DESCRIPTIVE REPORT

Registry No. H-11232

Project OPR-P182-RA-03
Southwest Alaska Peninsula, Alaska
Scale 1:10,000
July - August 2003
NOAA Ship RAINIER
Chief of Party: Commander John W. Humphrey, NOAA

Revisions Compiled During Office Processing and Certification

Figure 2. H11232 Junction Surveys.

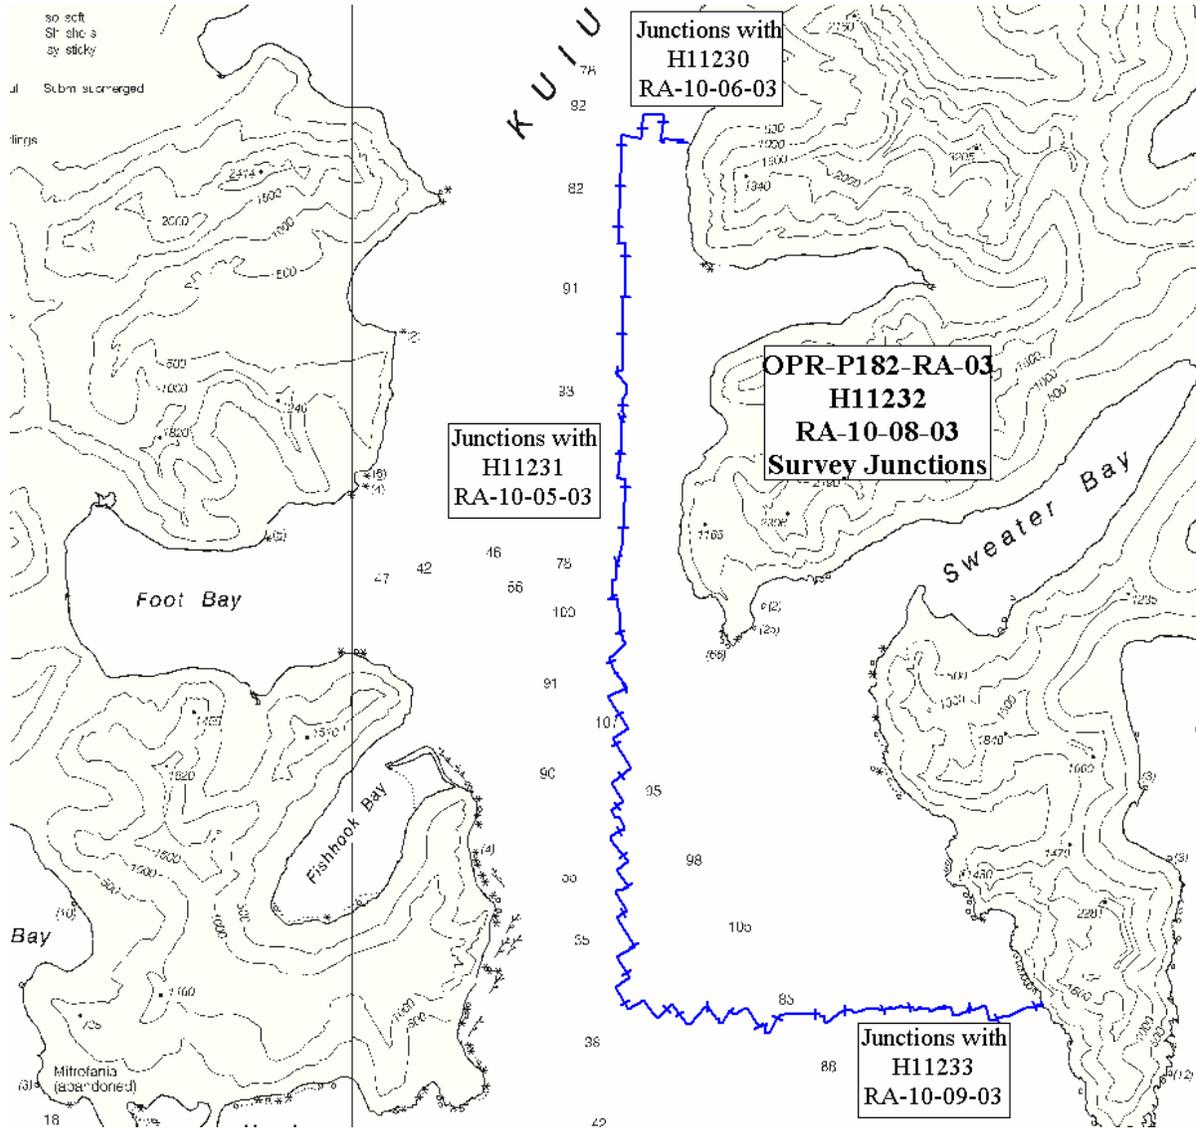
The following contemporary survey junctions with H11232: ⁵

Registry #	Scale	Date	Junction side
H11230	1:10,000	2003	North
H11231	1:10,000	2003	West
H11233	1:10,000	2003	South

Surveys H11230, H11231 and H11233 all junction well with this survey, a cursory comparison indicates differences are generally less than one fathom.⁶

⁵ Concur. In PHB processing, H11232 was also compared at its southeastern junction with LIDAR survey H11260 (OPR-P182-KRL-04). The comparison showed good correlation, generally to within 1 to 2 fathoms. MHWL revisions and features from LIDAR data have been applied to the Hdrawing in near-shore areas where H11232 multibeam or VBES data did not extend. Data from LIDAR source is found on Level 7 of the Hdrawing. All junction surveys have been considered in compiling the Hdrawing.
